WRU8 - Replacing Tailpipe Trim (Workshop Campaign)

Model Year: **2025**

Model Line: **911 (992)**

Concerns: **Tailpipe trim**

Installation position of tailpipe trim

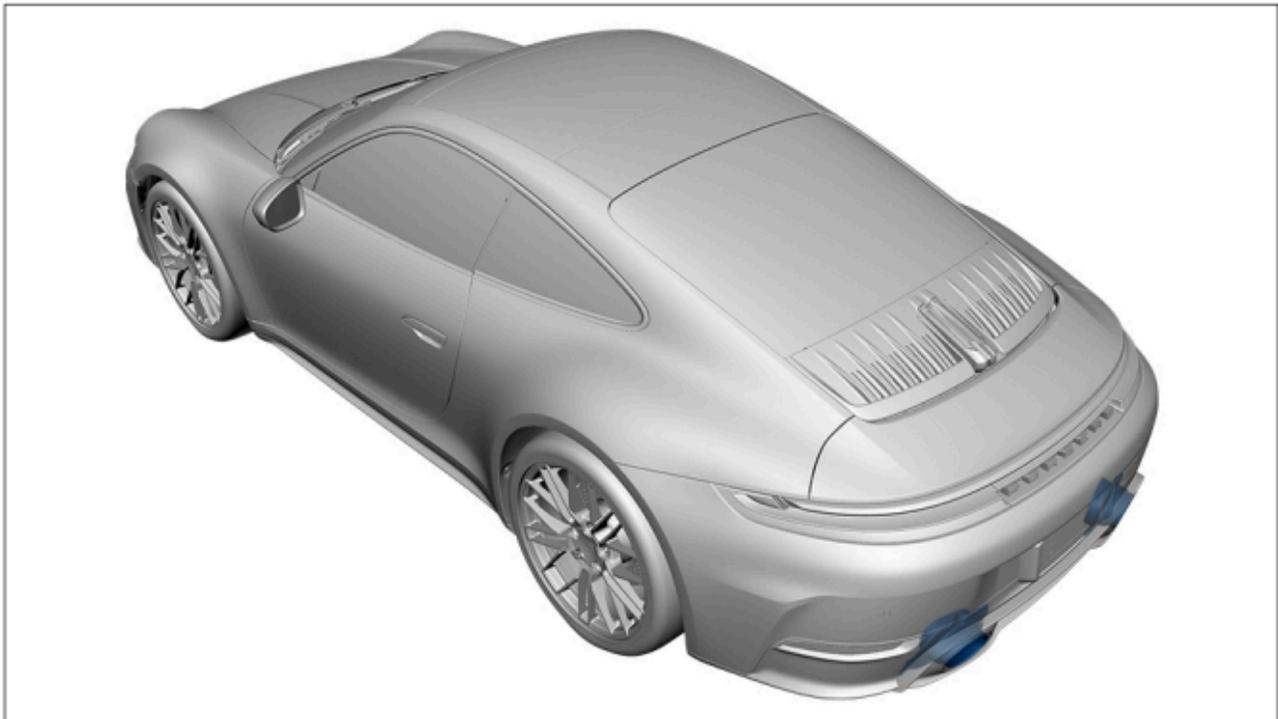
Cause: **During in-house quality analyses, it was determined that tailpipe trim that does not meet the required specifications had been installed on the affected vehicles.**
 In conjunction with high thermal loads, such as during longer high-speed driving, the air intake frame of the rear apron may become thermally deformed over its service life.
 Customers might consider this as a visual detriment.

Action: Replace the tailpipe trim.

Work Procedure: 1 Replace previous tailpipe covers with **tailpipe trim with optimized component status**.
